## CCPS RFP#25-04 – NORTH EAST MIDDLE/HIGH SCHOOL REPLACEMENT PROJECT

### ADDENDUM #7

**This addendum is to provide the pre-bid agenda and attendance list and issued revisions to the contract documents as noted below.** Proposers and related parties will be responsible for reading and understanding all documents, the scope of work, addenda and all related solicitation documents issued. These documents will become attached to and part of the solicitation and award of bid contract.

1. **ASIs 01 and 02**
2. **PR 01**
3. **CLOSED RFIs 001- 0027, 029-031, 034. (open RFIs are excluded)**

A7 TYP. FOUNDATION DETAIL W. CMU BACK-UP  
1 1/2" = 1'-0"

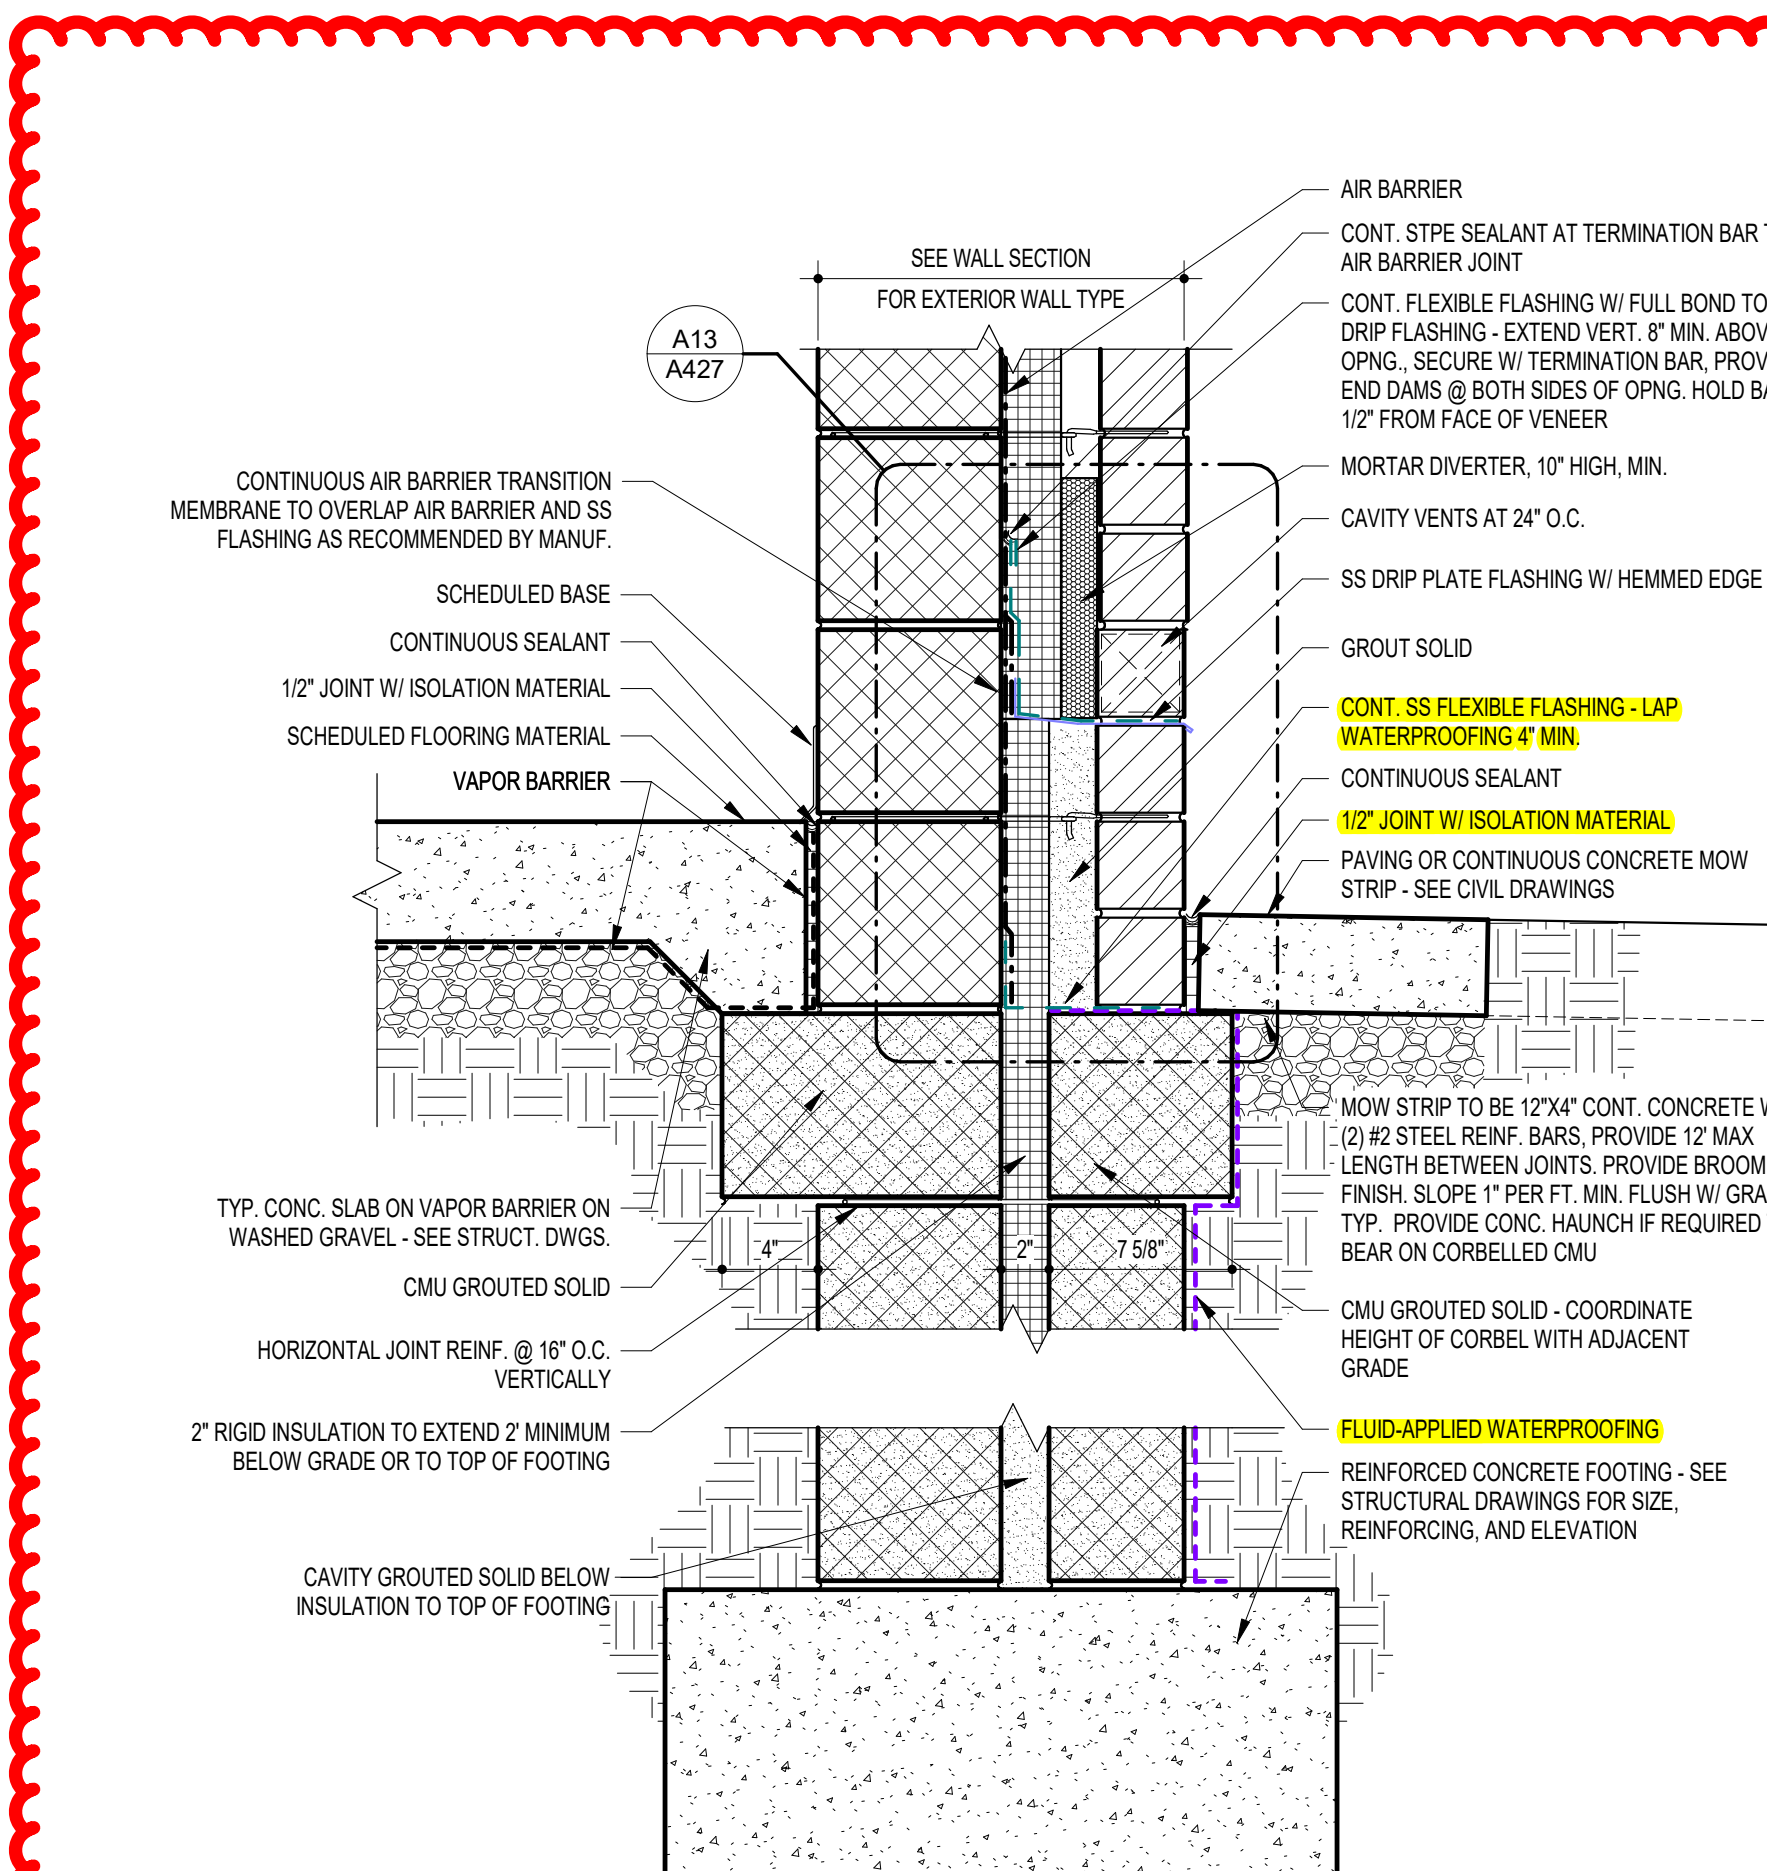
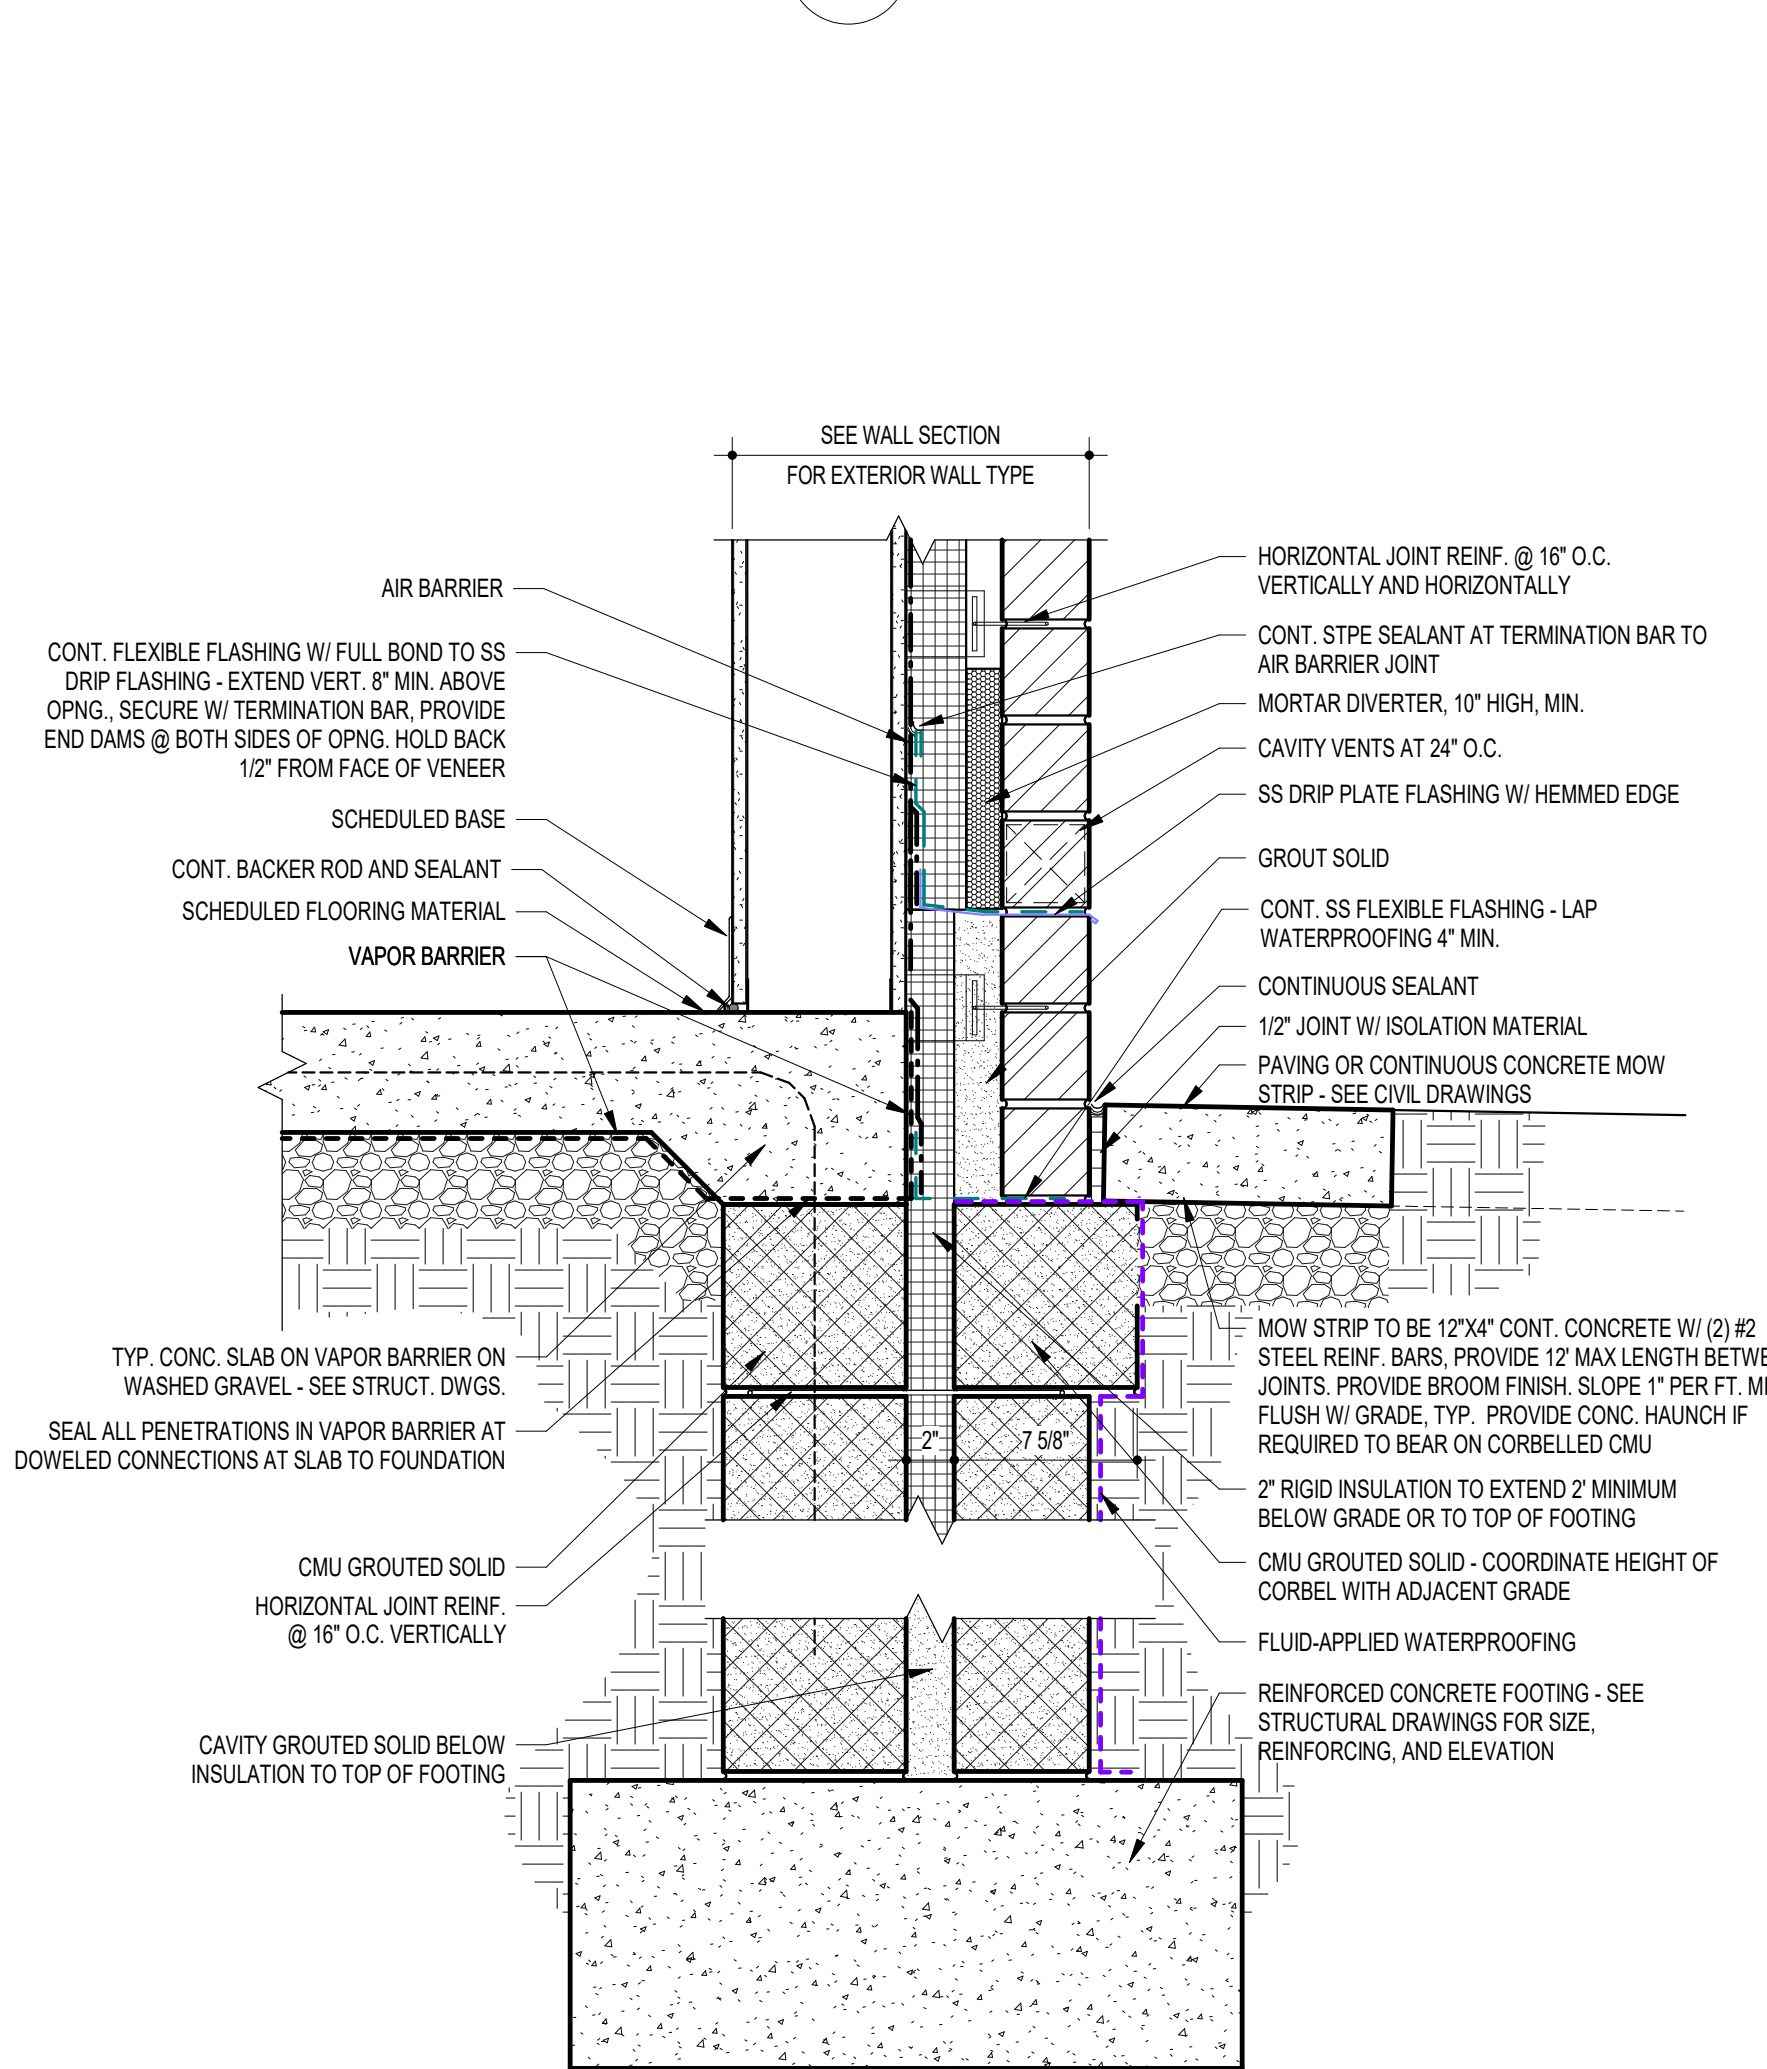
Activities	By	At
Joshua, Detail A7/A427 shows the waterproofing extending on the horizontal surface of the footing. See below. Thanks, Patrick	Patrick Byrne	Jul 8, 2024, 2:48 PM EDT
<b>Joshua Postadan</b> changed the status from  <b>Closed</b> to  <b>Open</b> Answered set Ball in court to <b>Joshua Postadan</b> (HESS Construction Co., LLC) changed the <b>ID</b> to <b>009.1</b>	Joshua Postadan	Jul 8, 2024, 2:37 PM EDT
Patrick, 07 11 13 Section 3.3 B calls for the dampproofing to extend over top of footing and down a minimum of 6 inches, whereas Detail A7/A427 shows the dampproofing terminating at the top of footing. Please advise whether the dampproofing should be applied per the detail or the specification and please revise the detail/specification accordingly.	Joshua Postadan	Jul 8, 2024, 2:37 PM EDT
<b>Joshua Postadan</b> changed the status from  <b>Open</b> Answered to  <b>Closed</b> <b>Official response:</b> Patrick Byrne (Grimm and Parker): See attached RFI response. set Ball in court to <b>Glenn Feldstein</b> (George Moehrle Masonry)	Joshua Postadan	Jul 8, 2024, 9:57 AM EDT

Install the waterproofing as shown on the detail A7/A427 on the outer wythe of the CMU wall.
